UNITED STATES
NUCLEAR REGULATORY COMMISSION

SUBJECT: NRC SPECIAL INSPECTION REPORT - INDIAN POINT UNIT 2
STEAM GENERATOR TUBE FAILURE - REPORT NO. 05000247/2000-010

Report No. 05000247/2000-010

Facility: Indian Point 2 Nuclear Power Plant

Figure 5 - Crack in tube 2-67 of steam generator 24, found in 1997.

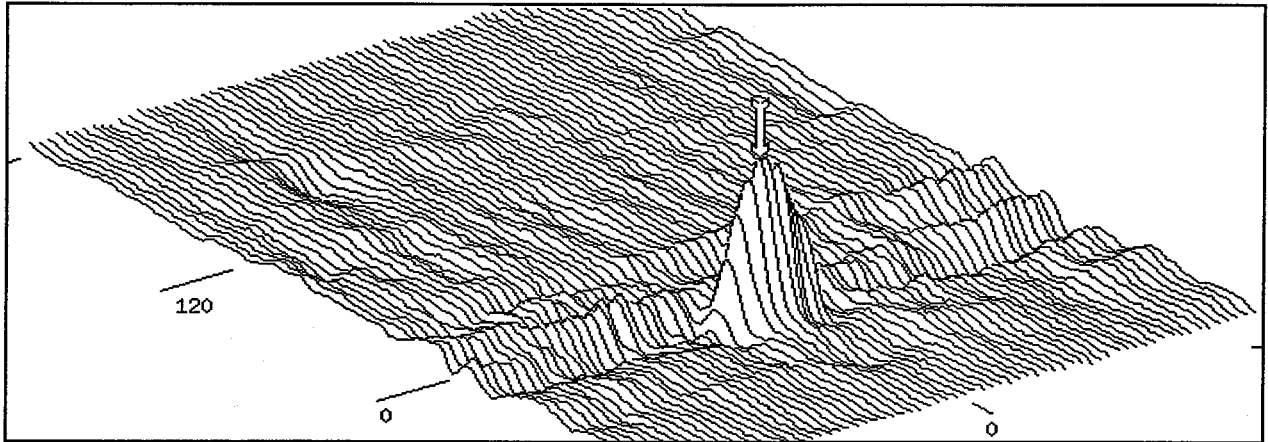
The c-scan plot of the 1997 data from R2C67 is shown in Figure 5. The crack sits beside a noise ridge, in a valley, and is in an easily detectable portion of the tube. The large amplitude of the voltage signal, in relation to the standard calibration notch, would indicate that this is a "mature" crack. No year 2000 data is available since the tube was plugged in 1997.

Figure 6 R2C5C-scan with 1997 phase setting.

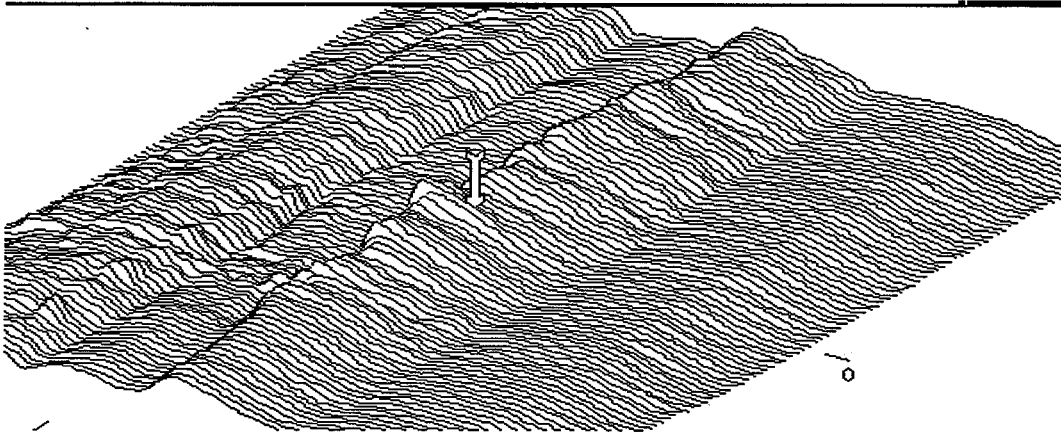
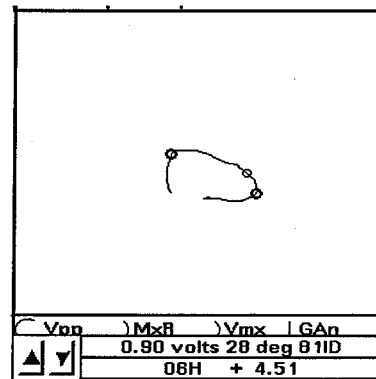
1. R2C5 in SG 24 - Figure 6 is a c-scan plot of the vertical component of the ECT voltage signal. The defect signal, indicated by the arrow, sits on a noise ridge that runs the length of the tube. This noise ridge is about 1-volt in amplitude. This ridge makes both the detection and sizing of this defect difficult, because of the very low signal-to-noise ratio. Figures 7 and 8 are the lissajous plots for the flaw area and the noise ridge, respectively. No year 2000 data is available since the tube failed.

REFERENCED FIGURES - 9 thru 10 - Eddy Current Inspection - Tube R2C69 in SG 24

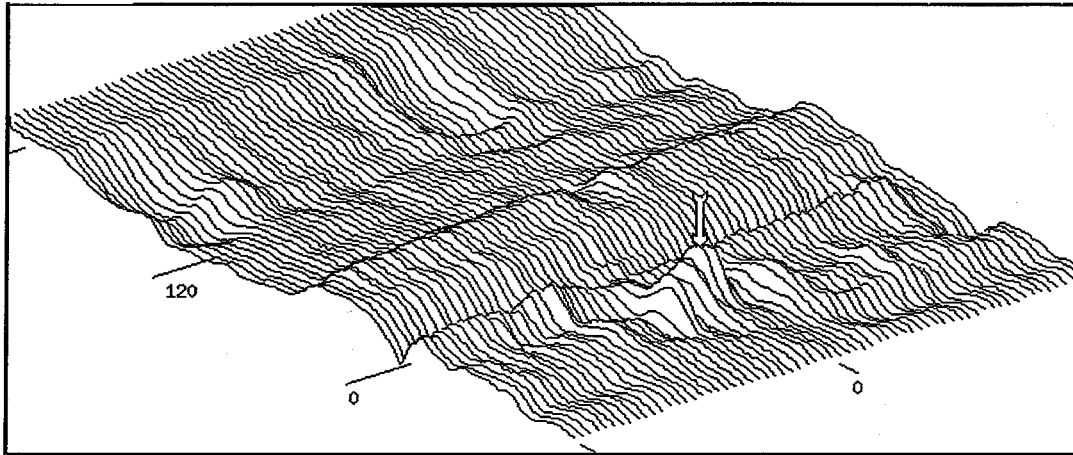
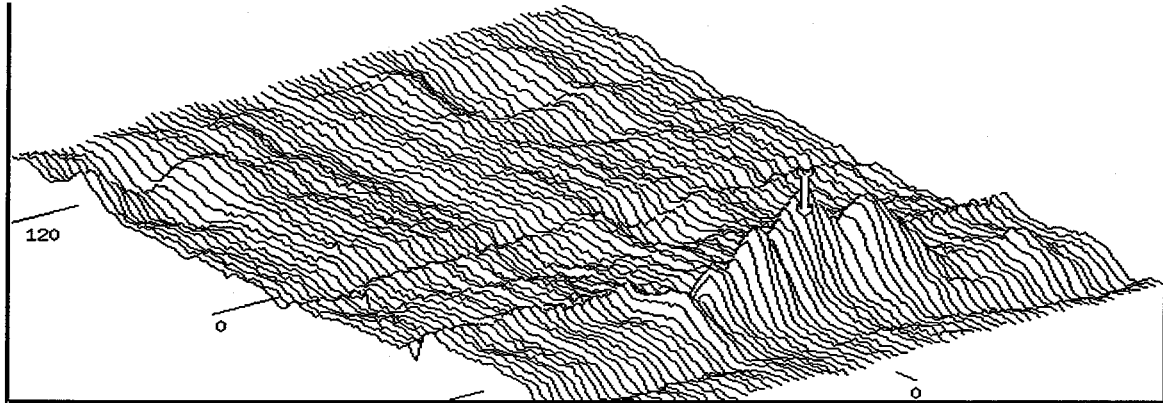
2. R2C69 in SG 24 - Figure 9 shows the c-scan plot for the 1997 data. There is considerable noise present. For comparison, the c-scan plot for the 2000 data is included as Figure 10. The noise features between the 1997 and 2000 data are similar enough to verify that this is the same defect at the same location. The defect voltage is only about 1 volt, and there is a considerable amount of noise on the tube relative to the defect signal, i.e., low signal-to-noise ratio.

REFERENCED FIGURES 11 thru -12 - Eddy Current Inspection Tube R2C72 in SG 24

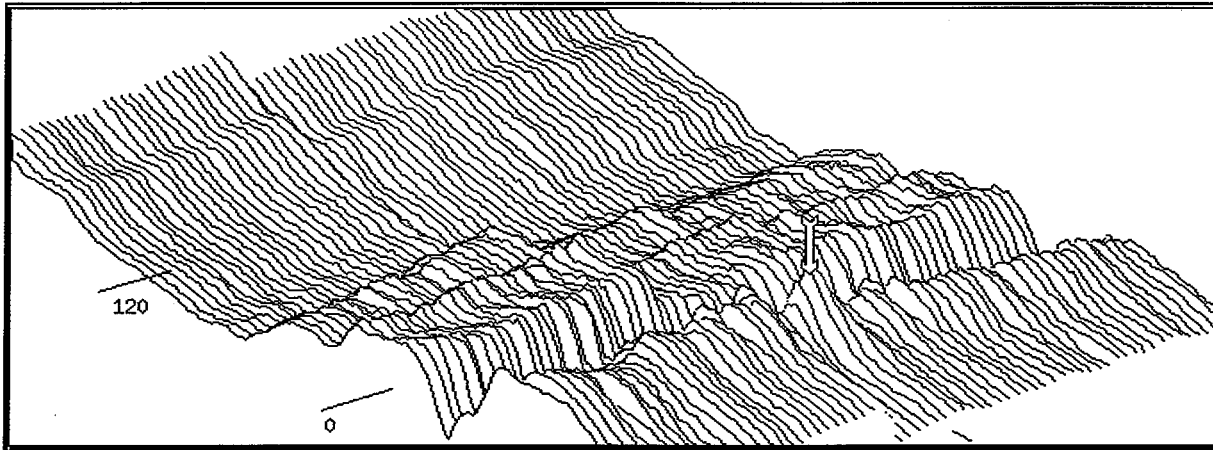
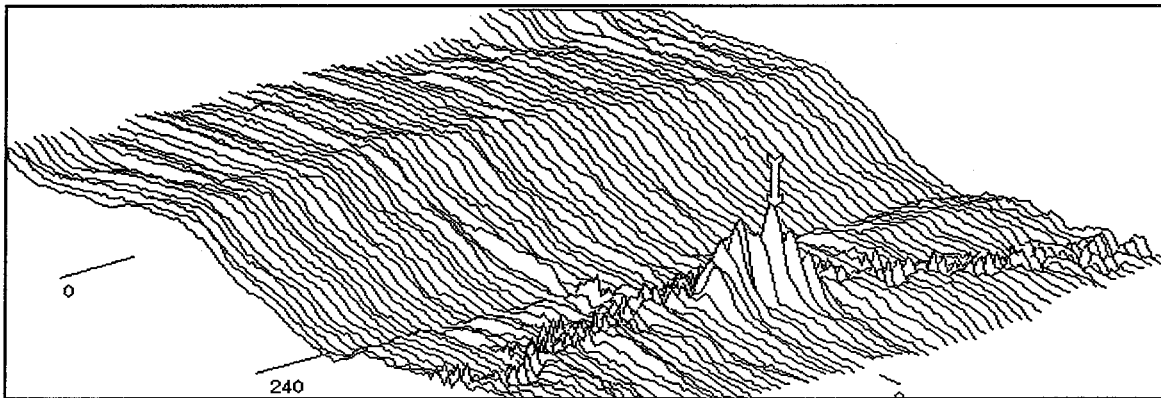
3. R2C72 in SG 24 - Figure 11 shows the c-scan plot of the 1997 data. There is considerable noise present. The crack is sitting in a ridge of noise and barely extends above the ridge. For comparison, the c-scan plot for the 2000 data is included as Figure 12. The crack barely extends above a 1-volt amplitude for a short length and exhibits a low signal-to-noise ratio.
4. R2C87 in SG 21 - this tube was identified as having several cracks. Figure 13 shows the c-scan plot of the 1997 data. The most prominent crack is sitting in a relatively clean area of the tube. For comparison, the c-scan plot for the 2000 data is included as Figure 14.
